**From:** Nicole Martin  
**Sent:** Friday, October 11, 2019 11:12 AM  
**To:** 'Mark Ausley'  
**Subject:** FW: Hartwood Marsh Residential - Application No. IND-069-158467-1  
**Attachments:** RE: Hartwood Marsh (158467-1)

**From:** Nicole Martin  
**Sent:** Thursday, August 8, 2019 5:41 PM  
**To:** Mark Ausley <mark@bio-techconsulting.com>; 'John T. Townsend, PE' <jtownsend@dwma.com>; devo@devoeng.com  
**Cc:** Sandra Joiner <SJoiner@sjrwm.com>; Nicole Martin <NMartin@sjrwm.com>  
**Subject:** Hartwood Marsh Residential - Application No. IND-069-158467-1

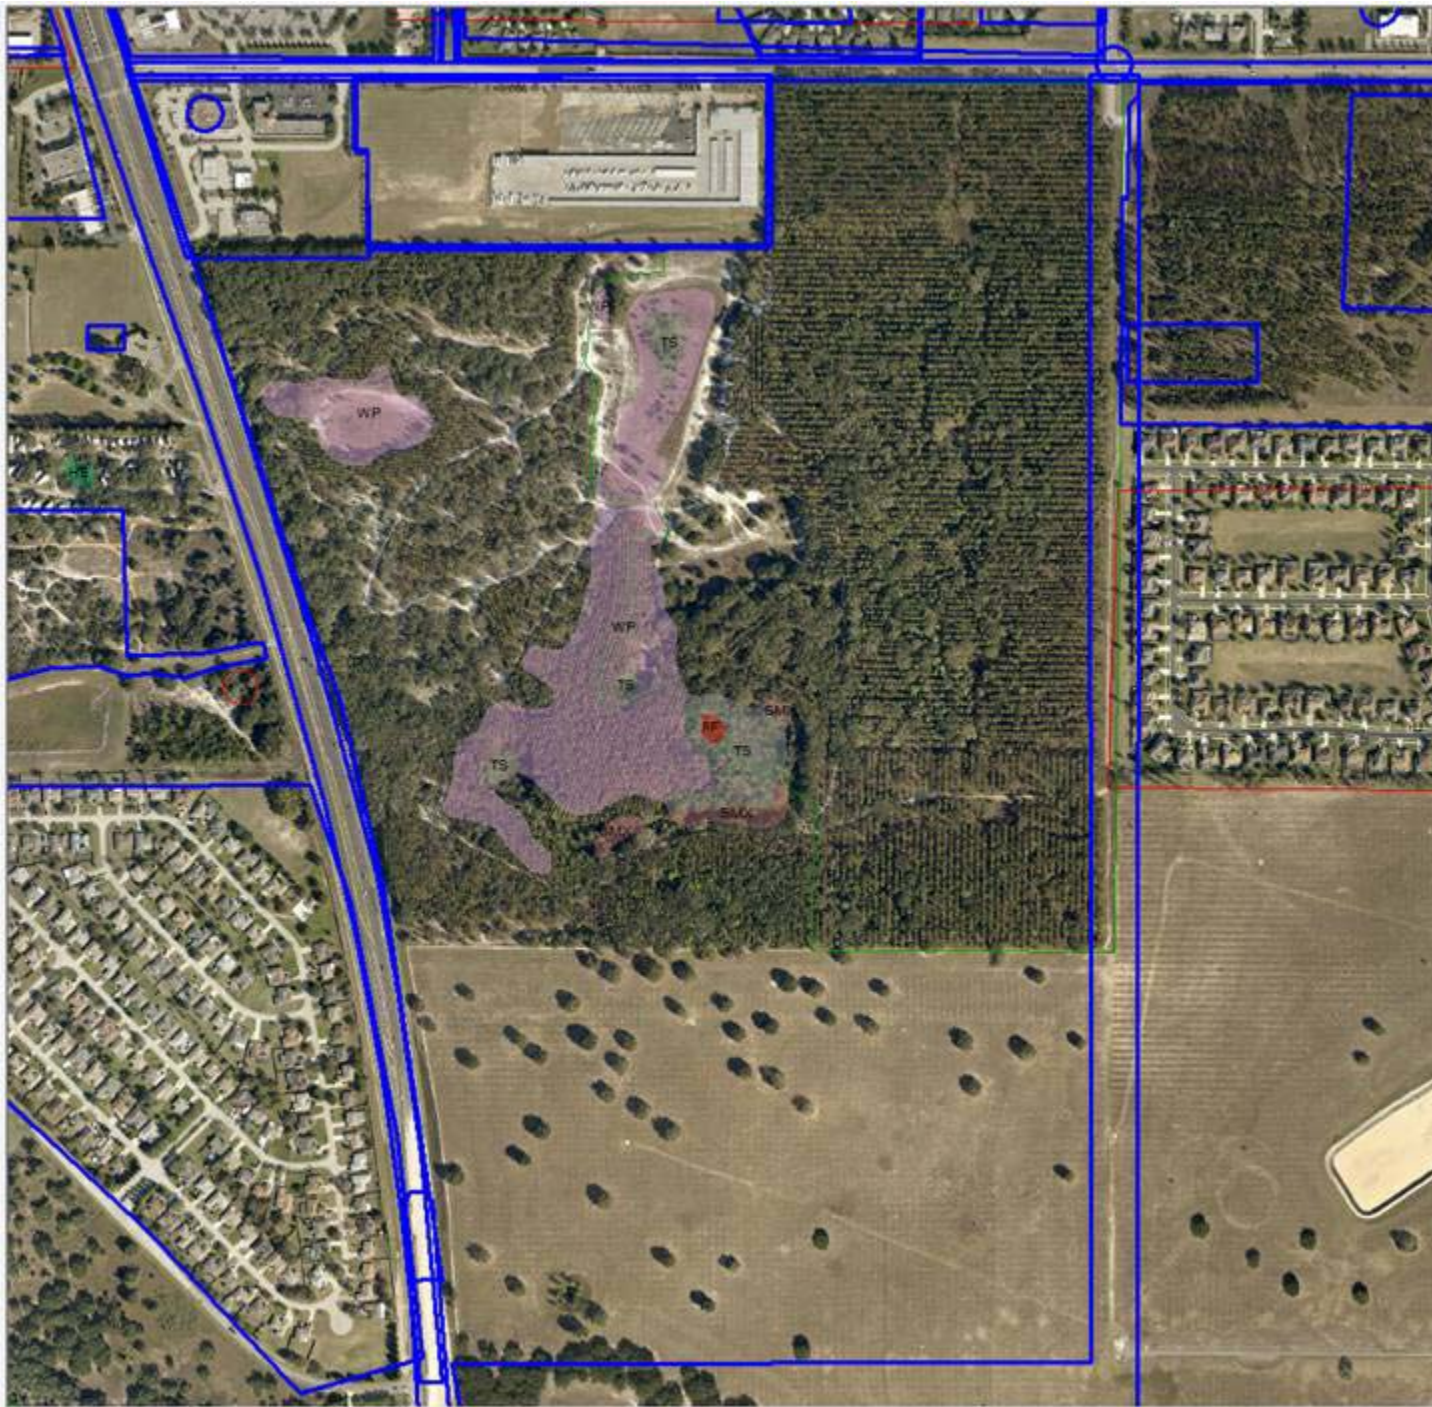
2. Aerials and GIS wetland and soil layers show additional areas within the project area and adjacent to the project area that may be wetlands/OSW beyond what is shown on the plans (see screen shot of the GIS wetlands/OSW layer below). A site visit needs to be scheduled with District staff; however, prior to scheduling the field visit to verify the flagged wetlands, please verify if additional wetlands/OSW exist within project area. If so, please provide an aerial figure that includes all the wetlands/OSW boundaries and the corresponding flag and flag numbers. Please note that the aerial figure with the wetlands/OSW boundary was not provided with the ER.
